**ADDENDUM NO. 3**

Date: August 21, 2023

**Project: Project #: 0146-465  
0146-465 Isador Cohen ES / Rosemont HS Security Improvements: Group 1**

SHEET NO.  
**C3.1**

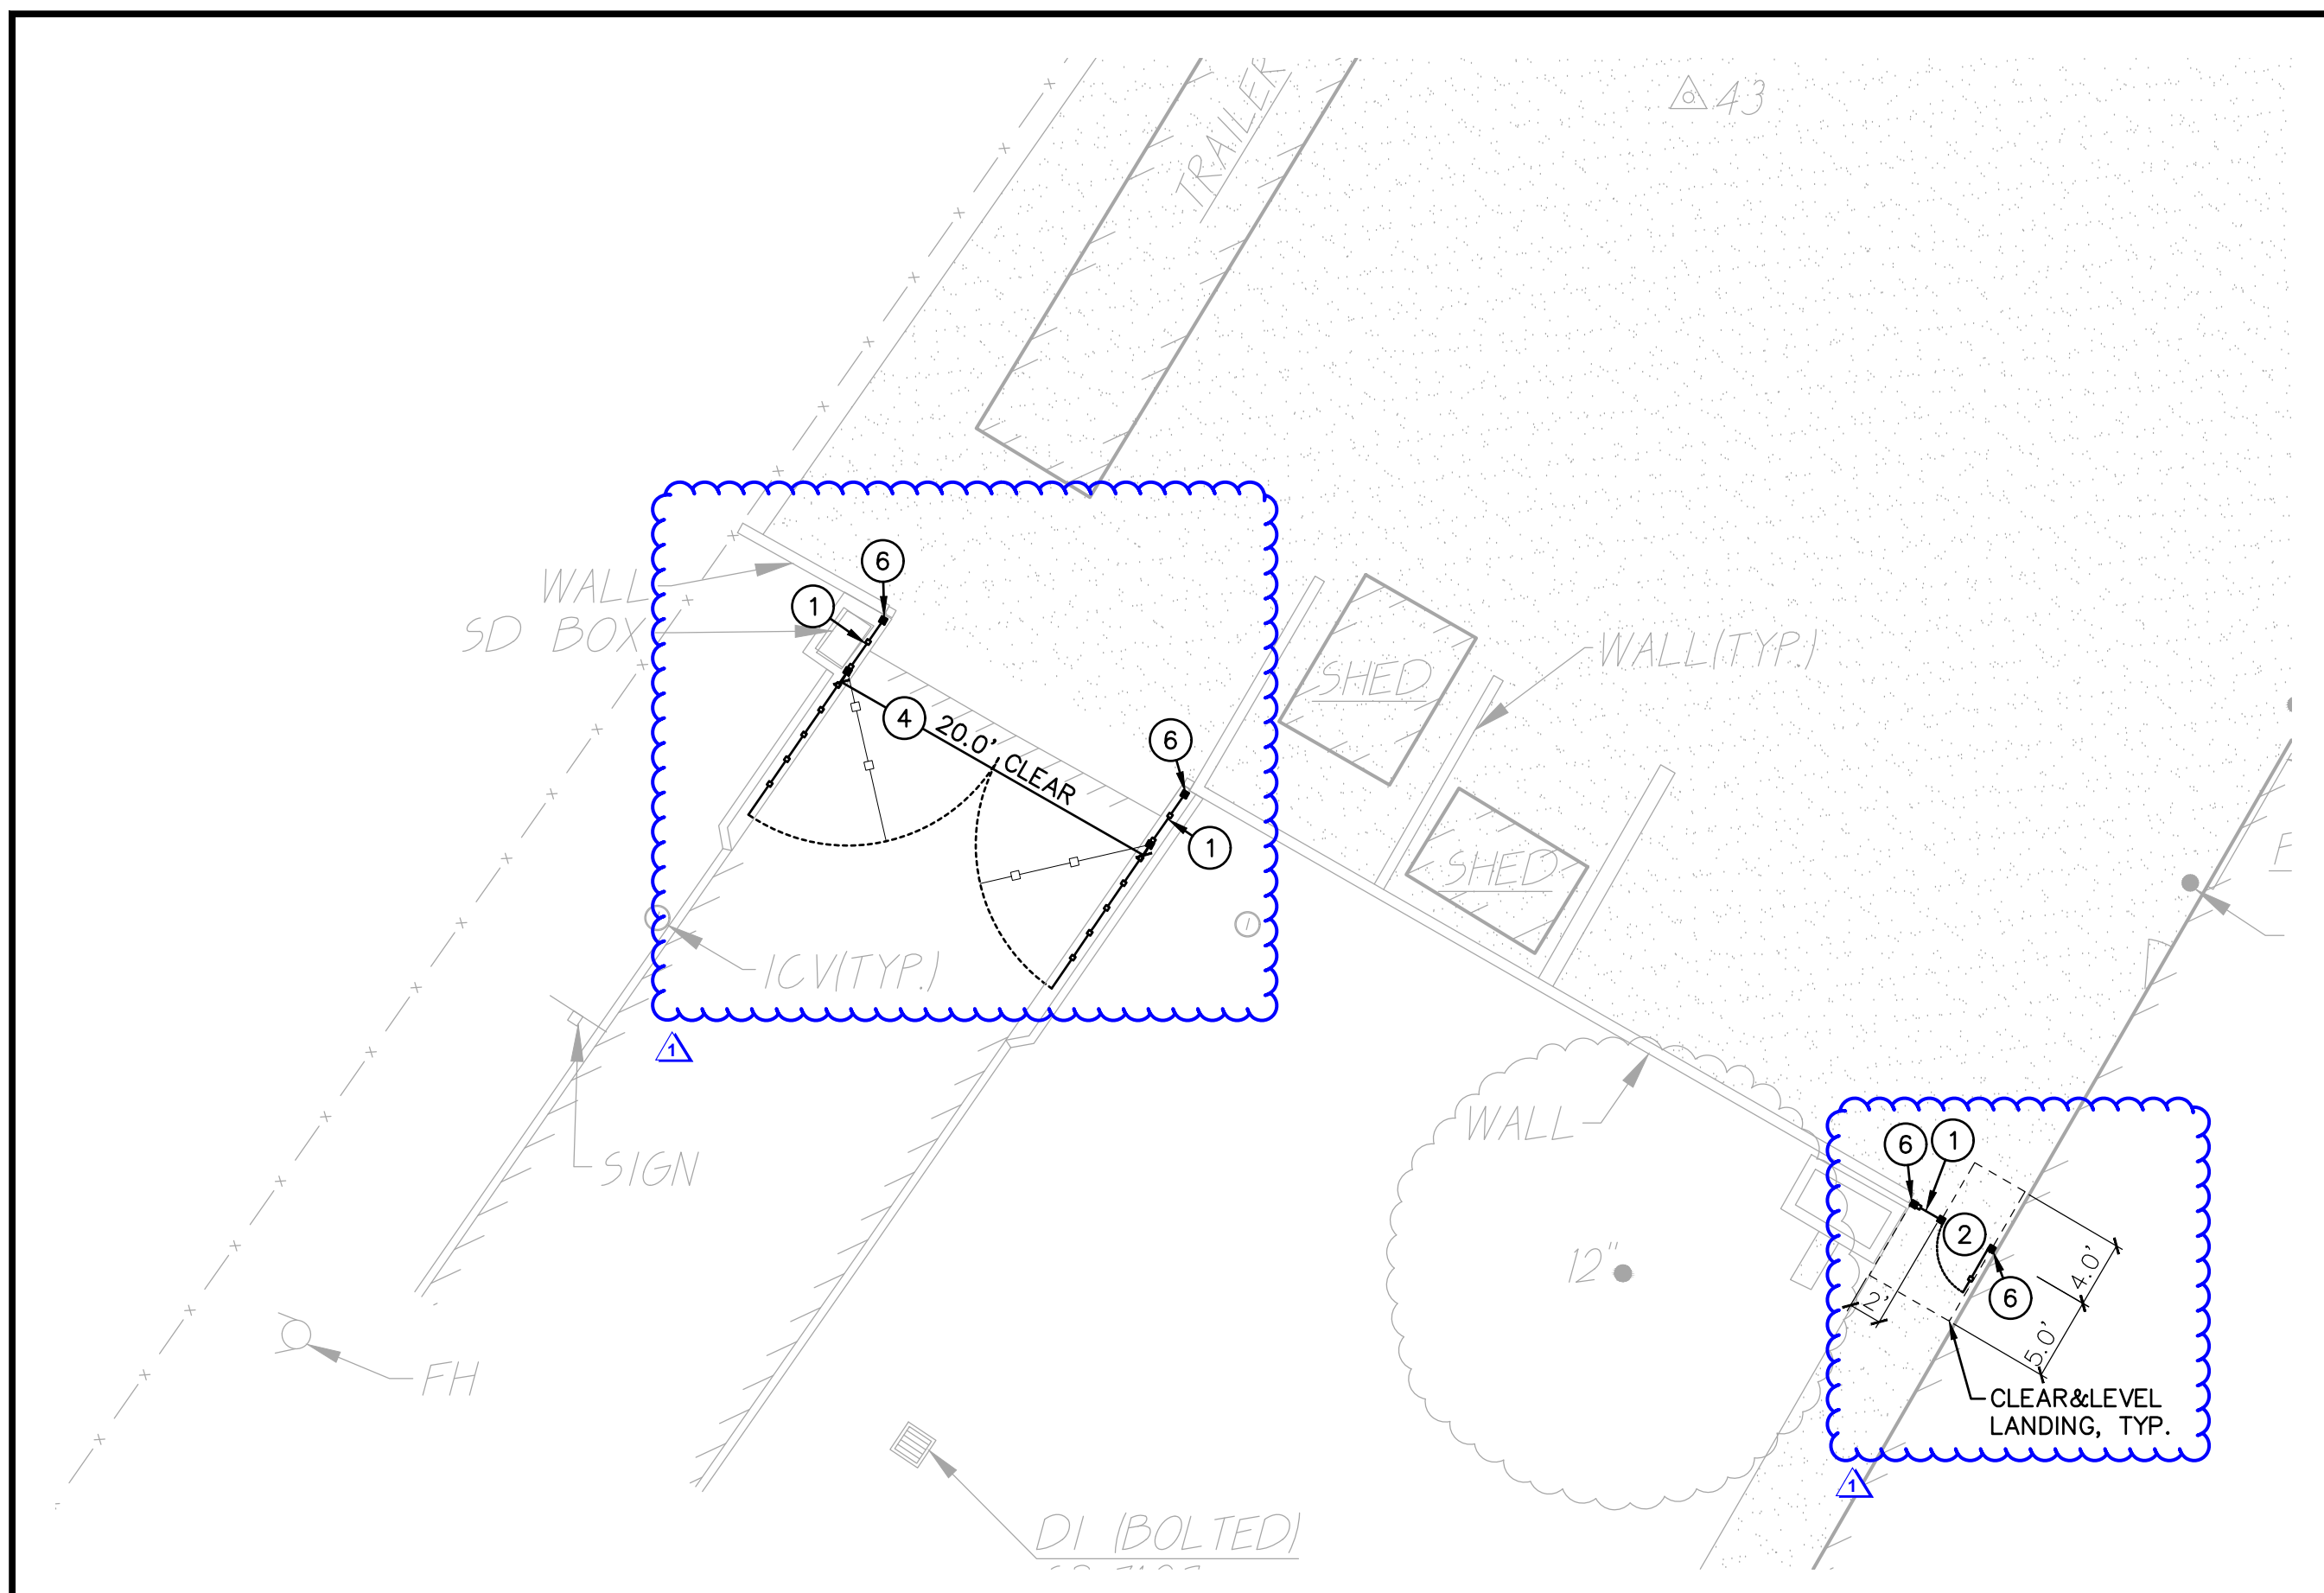
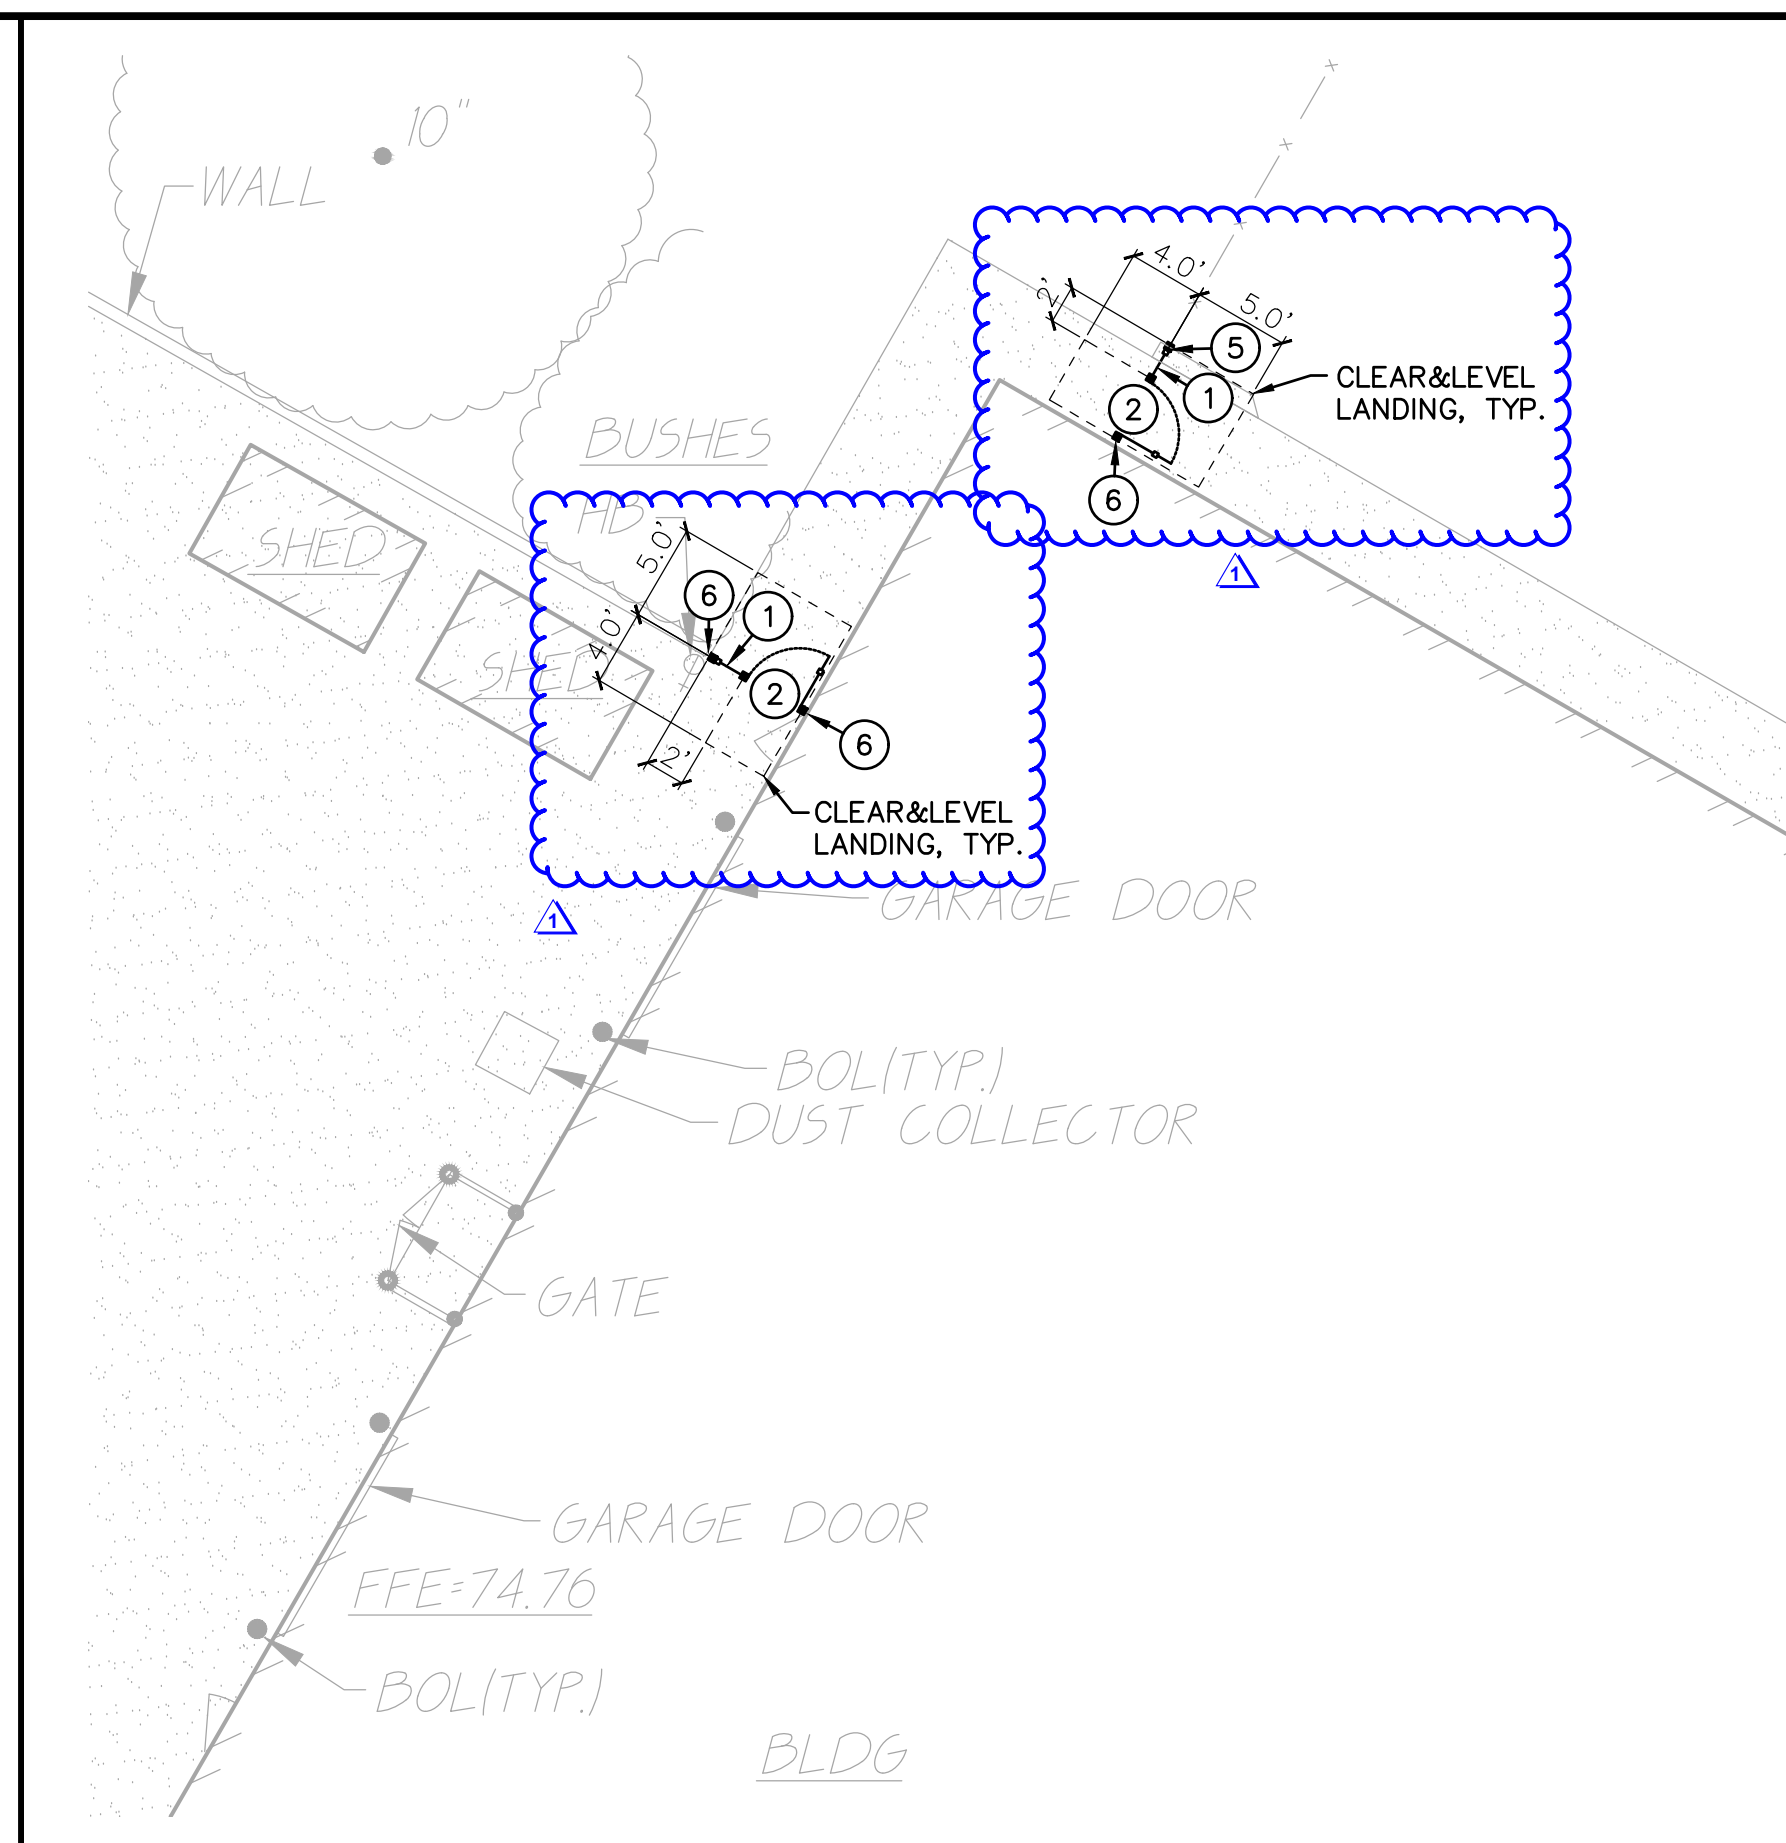
**Sheet C3.1**

- View 1 updated to change gate type in 2 locations.
- View 2 updated to change gate type in 2 locations.
- Ornamental fence note 2 updated.
- Ornamental fence note 3 updated to include additional detail reference.
- Chain link fence note 32 removed as it is no longer used.
- Chain link fence note 34 removed as it is no longer used.
